**Town of Kittery
Planning Board Meeting
May 11, 2023**

ITEM 2 – Green Truck Farm/ 89 Route 236 Site Plan Modification and New Marijuana Business Review

Proposal: change use of portion of existing commercial building to adult-use marijuana business and extend sewer main to serve the subject property.

Property: 89 Route 236; Tax Map 28, Lot 14-2

VEGETATED STORM WATER BASIN

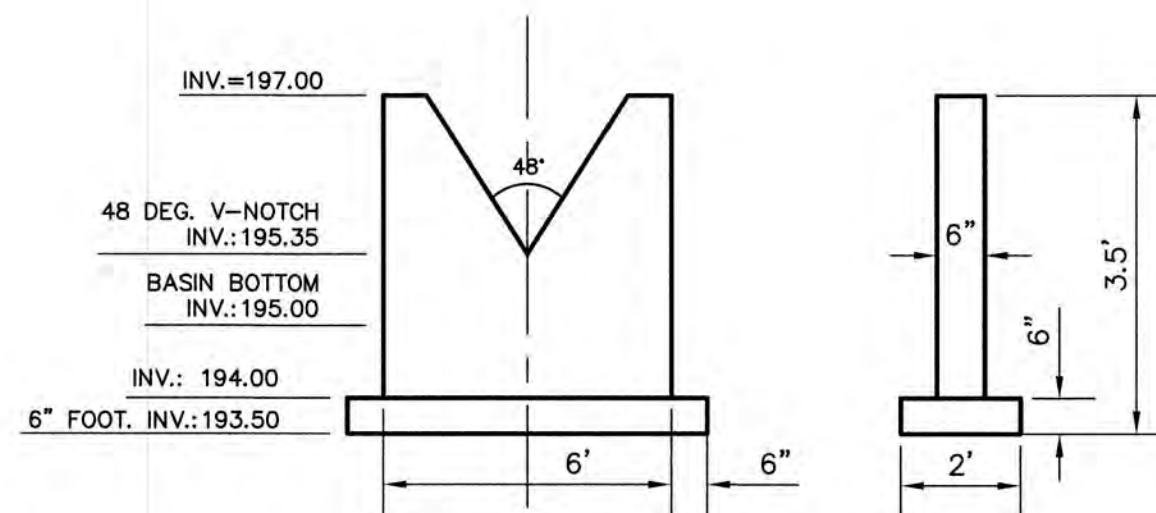
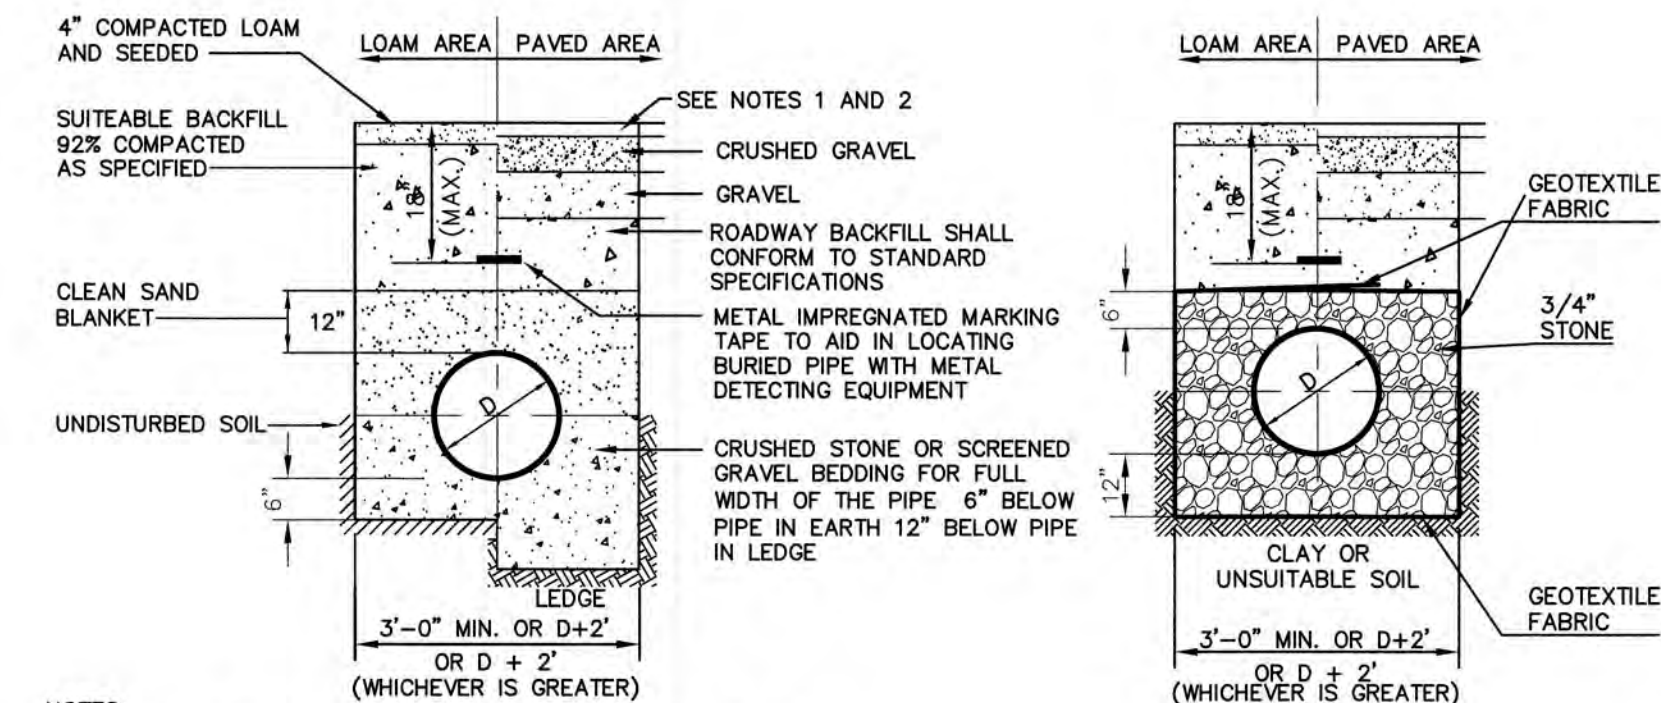
2. *The applicant should provide details for the stormwater basin and outlet structure. Leaders on Sheet C3 reference detail Sheet D1, but this was not included in the plan set.*

The applicant should provide details for the stormwater basin and outlet structure. Leaders on Sheet C3 reference detail sheet D1, but this was not included in the plan set.

RESPONSE: The details in question are included on Sheet D1. This Sheet has been included in the updated plan set included with this letter.
3. *Following the site walk the Town of Kittery requested additional information with respect to the classification of existing pond on site. Gove Environmental Services, Inc. provided a response letter and characterization of the stormwater feature as a detention pond and not a wetland. Their assessment includes discussion of a DEP Stormwater/Site Law permit for maintenance requirements. Does the applicant have this permit? A copy should be submitted to the Town for the project record.*
